**TO:** Cochise County Planning and Zoning Commission  
**FROM:** Christine McLachlan, AICP, Planning Division Manager  
**FOR:** Daniel Coxworth, AICP, Development Services Director  
**SUBJECT:** SU 23-26 (Cochise Stronghold Solar), Application for a Special Use Authorization  
**DATE:** November 27, 2023, for the December 13, 2023, Meeting

### APPLICATION FOR A SPECIAL USE (SU 23-26 Cochise Stronghold Solar)

Figure 6: Floodplain Map

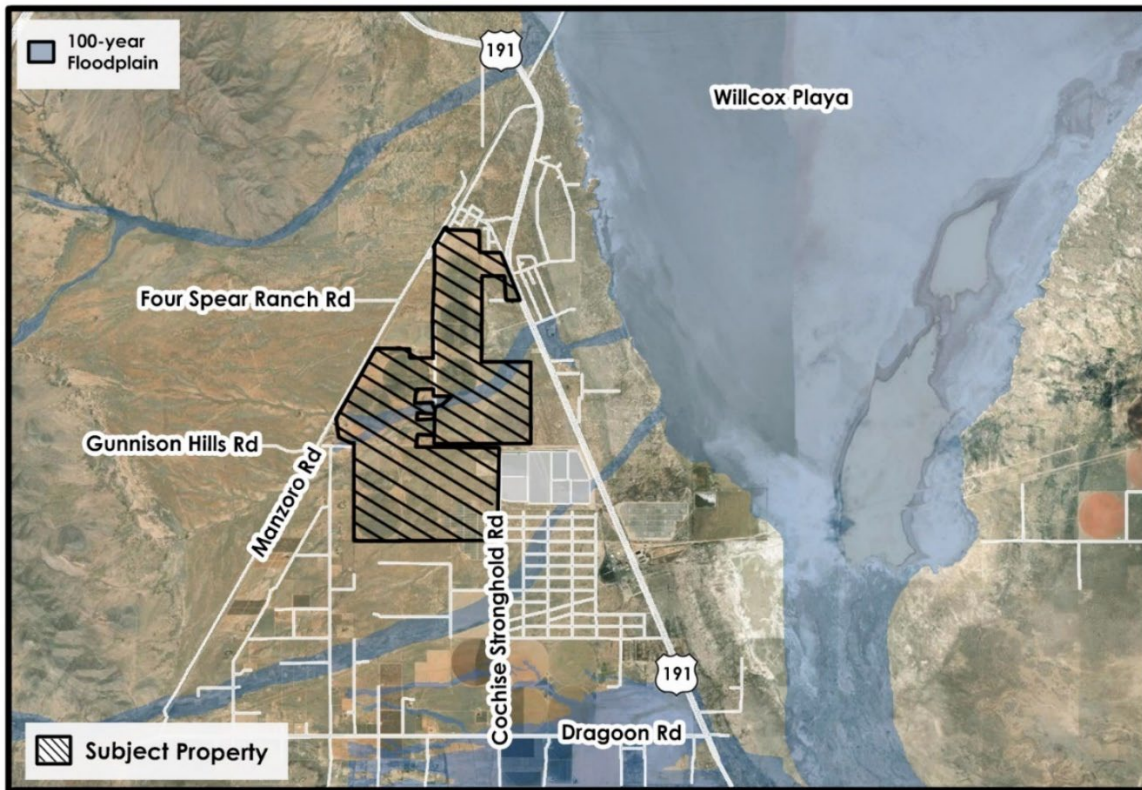
- Stormwater and Floodplains: A portion of the site is within the 100-year floodplain, as indicated on the graphic, below. The County will require a drainage analysis and floodplain use permit for the site during commercial permitting, if approved for special use authorization.

- **Recommended COA: Area within the 100-year floodplain shall remain free of any solar modules, batteries, inverters, transformers, and internal security fencing.**
